# A1237 Bridges Active Travel Scheme

Assessment of design proposals

City of York Council

April 2022

**Figure 4-3 - Extract from WSP's Options Report showing existing cross section arrangement**

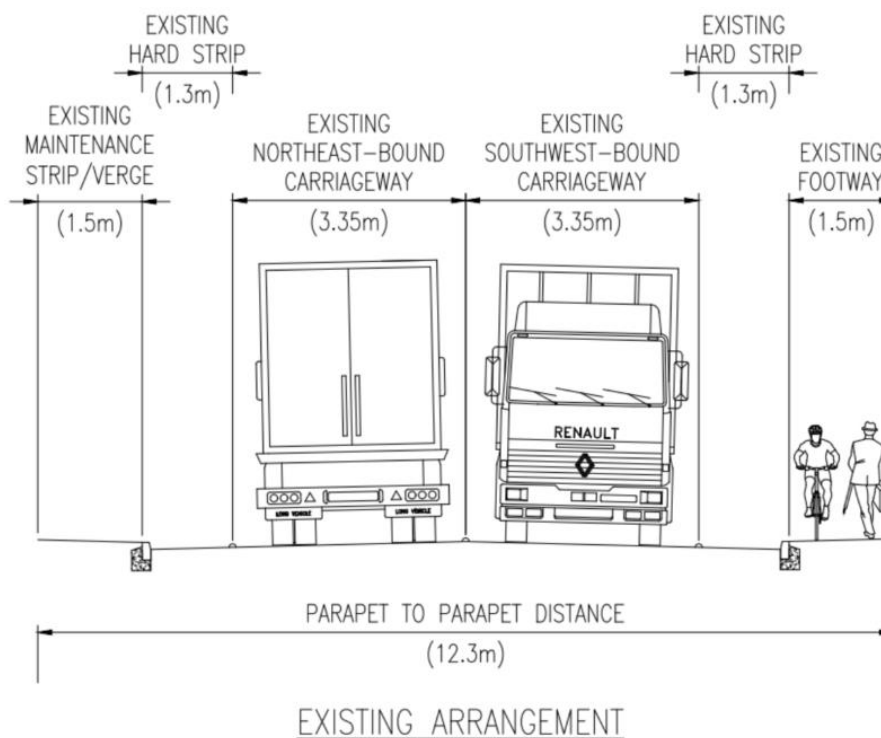
The scheme extends span two bridges: Rawcliffe Ings Bridge and Millfield Railway Bridge. The bridges carry the A1237 over the River Ouse and the East Coast Mainline (ECML) respectively and are approximately 48m apart. The WSP report included a typical existing cross section arrangement for the A1237 over both bridges which is duplicated here in Figure 4-3 for information. Figure 4-4 is a photograph showing a view of the existing arrangement with the shared use path along the south side of the carriageway.

Figure 6-1 - Extract from WSP's Options Report showing proposed cross section

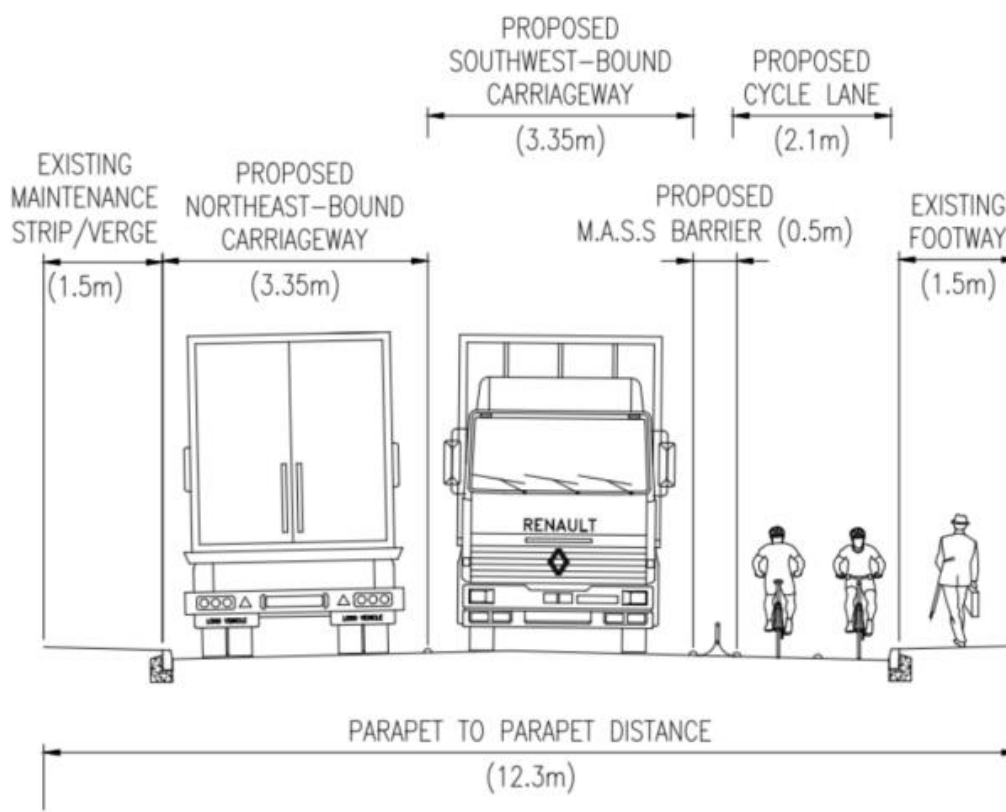
The proposed cross section below has been extracted from WSP's Option Report. In summary the proposals are to reduce the speed limit to 40mph and to install light segregation alongside a new bi-directional cycle lane (2.1m wide) that utilises reallocated road space. Traffic lanes would be reduced to 3.35m<sup>3</sup> wide and hardstrips removed. To avoid intrusive work on the bridge decks the light segregation element is to be formed by temporary traffic management barriers that can sit on top of the carriageway surface. The temporary barriers proposed are MASS barriers which require non-permanent fixing as the barriers are anchored with sandbags<sup>4</sup>

- The proposals provide light segregation alongside a carriageway with a 40mph speed limit. This does not align with the guidance in LTN 1/20 (Table 4-1) which recommends fully kerbed cycle tracks in 40mph speed limits. The table indicates that the provision of light segregation can exclude some users when used on a road with a 40mph speed limit, especially if there are other constraining features affecting the route.
- The proposals provide a 0.5m wide separation strip. According to LTN 1/20 (Table 6-1) the separation strip between a cycle lane and a traffic lane should be 1.0m wide for a road with a 40mph speed limit, with an absolute minimum width of 0.5m. The separation strip helps to protect cyclists from air turbulence. The proposals provide the absolute minimum, according to LTN 1/20.

Whilst the scheme proposal is to install light segregation the usual features used for light segregation, such as wands and orcas, are not permitted as they must be fixed into the bridge deck (See Section 6.4.5). Instead, a standard temporary vehicle restraint system is proposed. WSP's Options Report specifies 'MASS' barriers which are 500mm wide and 420mm high. The low height could heighten the sense of exposure and the proximity of cyclists to passing traffic could create crosswind buffeting effects on cyclists caused by large vehicles passing at 40mph.

The desirable setback of the barrier from the live lane is 600mm although this can be relaxed to 375mm subject to a risk assessment (DMRB CD377, Table 9.17). Using a MASS barrier, within a 500mm separation strip and a 200mm wide marginal strip would not provide the desirable setback, it would provide circa 350mm setback (the actual setback requires verification by the manufacturer). Reductions from the desirable setback bring moving traffic closer to the barrier and the risk of collisions with it, especially in the hours of darkness and when there are strong winds.

- The proposals provide a 2.1m wide bi-directional cycle track. According to LTN 1/20 the desirable two-way cycle route width is 3.0m, with an absolute minimum width of 2.0m for cycle flows of 300 or less per hour (Table 5-2, LTN 1/20).
- The proposed cycle track is bound on one side by a 100mm high kerb and on the other side by a 420mm high barrier. According to LTN 1/20 (Table 5-3) an additional width of 200mm is required to maintain effective cycle track width next to a kerb, and 250mm for a cycle track next to a vertical feature up to 600mm high.
- According to LTN 1/20 the absolute minimum width for the cycle track should be 2.45m (2.0m+0.2m+0.25m). Therefore the proposed 2.1m width does not meet with LTN 1/20 absolute minimum recommended provision.

Based on these figures it can be surmised that at a 2.1m absolute minimum width (as proposed) there would need to be a compromise in speed and position for two cyclists to safely pass in opposing directions. The concern at this site is that the constrained section is approx. 425m long and the bounding features (a vertical faced drainage kerb and a barrier with a curved profile) could become collision hazards for cyclists deviating from their path or stopping and putting a foot down on an uneven surface. Place this in the context of a midwinter's peak hour and the cyclists have to navigate the route and each other in darkness as the route is not lit.
